Project	IEEE 802.16 Broadband Wireless Access Working Group < http://ieee802.org/16 >	
Title	Changes to the Sections 15.3.2, 15.3.2.1, 15.3.2.2, & 15.3.2.3 re:Coexistence Messaging Mechanism	
Date Submitted	2007-01-17	
Source(s)	John Sydor Communications Research Centre 3701 Carling Avenue Ottawa, Ontario	Voice: 613-998-2388 Fax: [Fax Number] john.sydor@crc.ca
Re:	Changes to Draft Standard	
Abstract	Editorial changes to provide clarity and change terms common to draft standard	
Purpose	Add consistency and clarity to draft document.	
Notice	This document has been prepared to assist IEEE 802.16. It is offered as a basis for discussion and is not binding on the contributing individual(s) or organization(s). The material in this document is subject to change in form and content after further study. The contributor(s) reserve(s) the right to add, amend or withdraw material contained herein.	
Release	The contributor grants a free, irrevocable license to the IEEE to incorporate material contained in this contribution, and any modifications thereof, in the creation of an IEEE Standards publication; to copyright in the IEEE's name any IEEE Standards publication even though it may include po

Figure h35 ~~CCD~~ Candidate Channel Determination Process

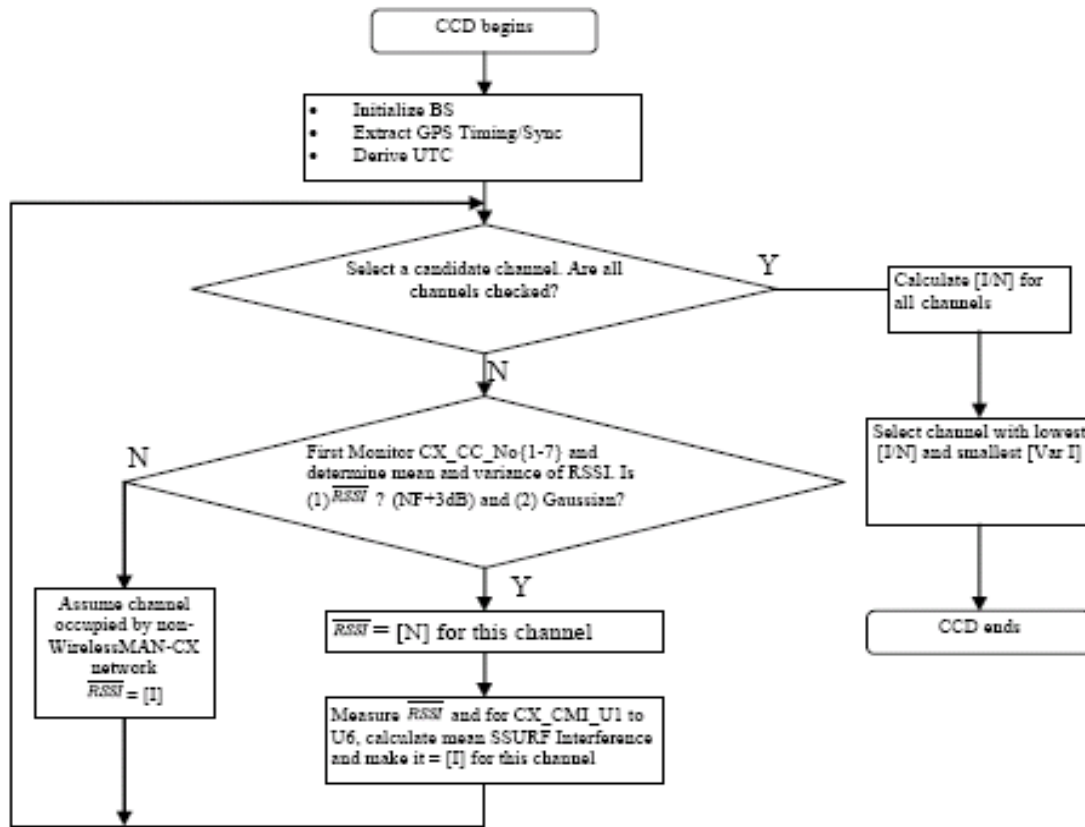
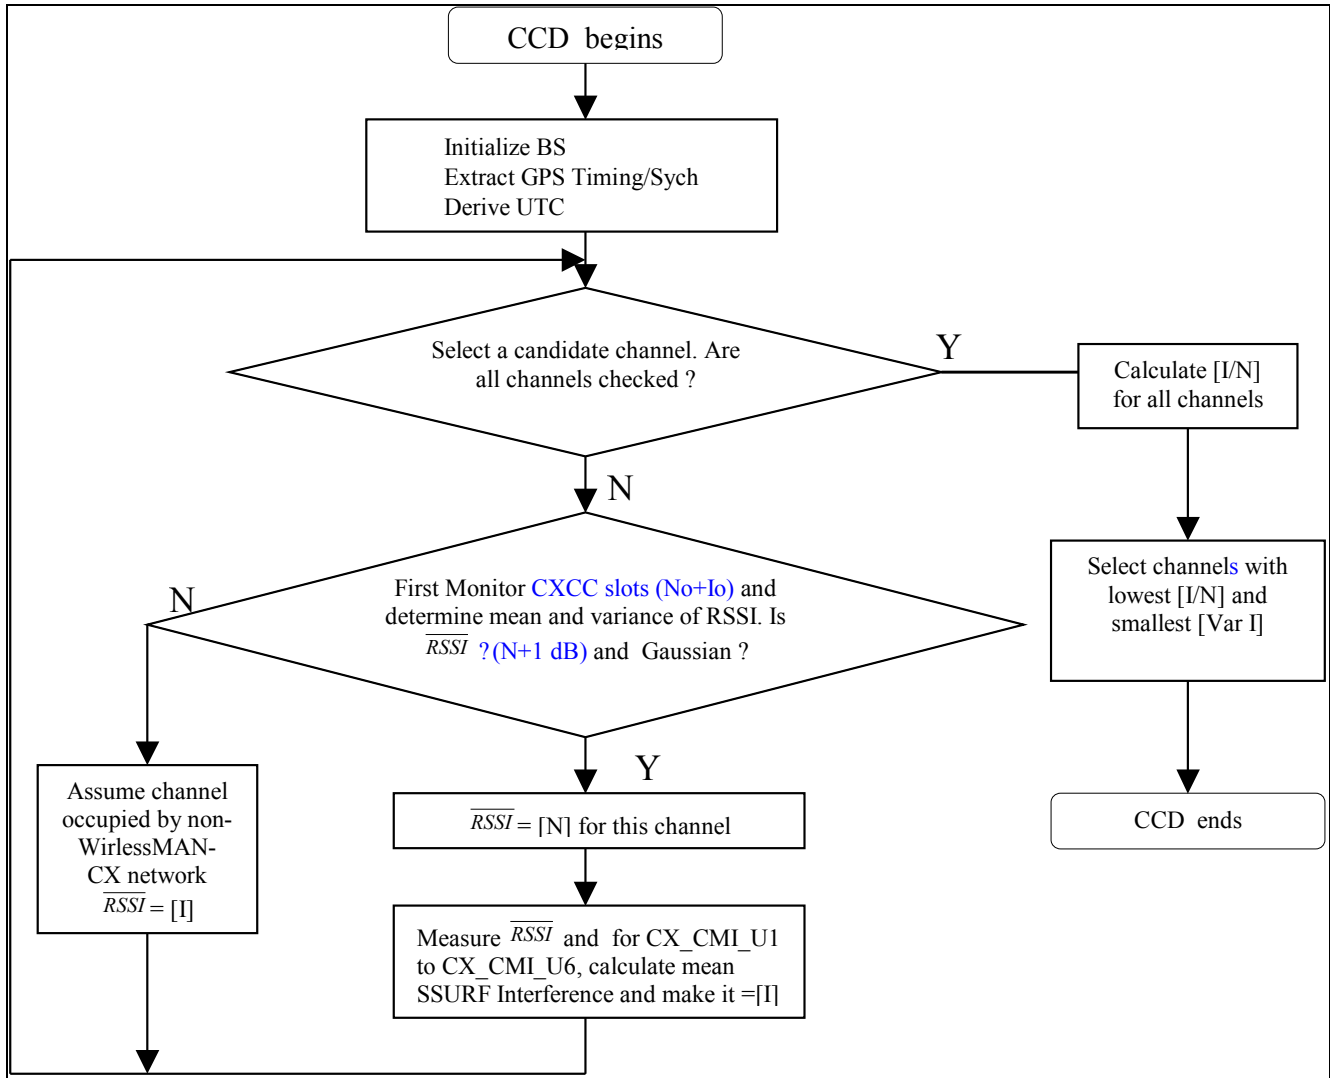
Delete the following figure h35 found between lines 1 and 36 of page 75 of [1]

*Replace the figure h35 deleted above with the following figure. The markings in **Blue** represent the changes between the above figure and the new figure below.*

Figure h36 CMI Identification and Claiming and IBS Community Entry Process Using CMI Signaling on the CXCC

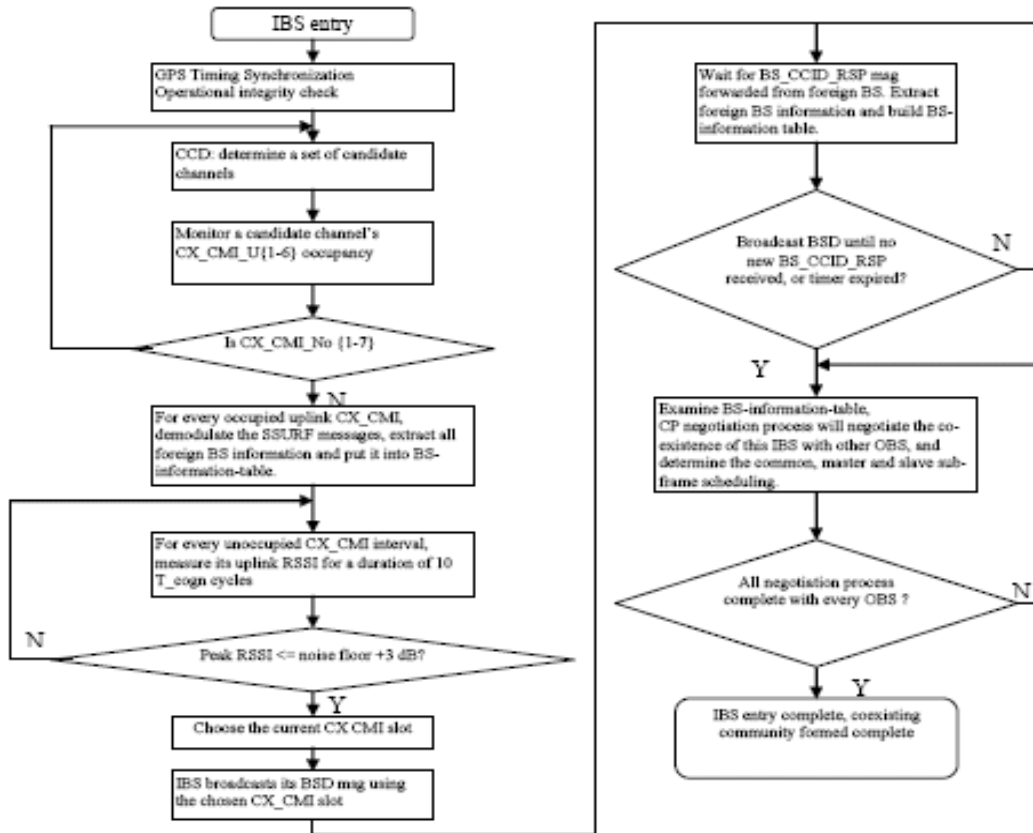
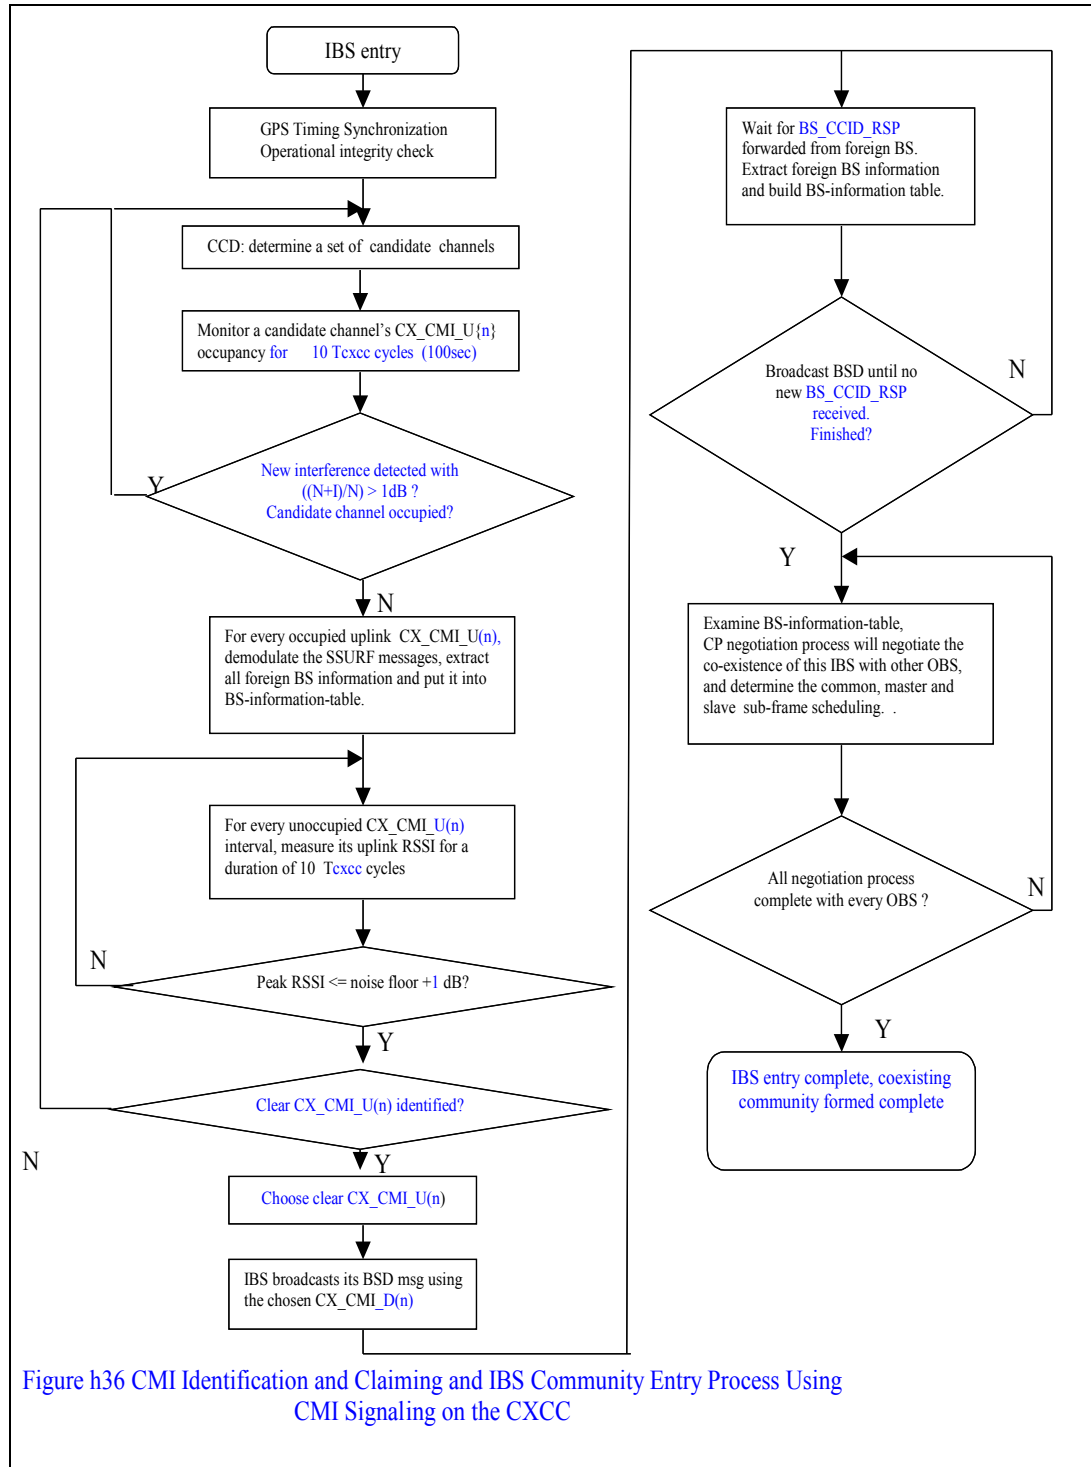
Delete the following figure h36 currently found between line 30 of page 77 and line 2 of page 78 of [1].

*Insert the following figure between line 30 of page 77 and line 2 of page 78 of [1]. This figure to replace the one deleted immediately above. The **Blue text** represents the change between*

the two figures.
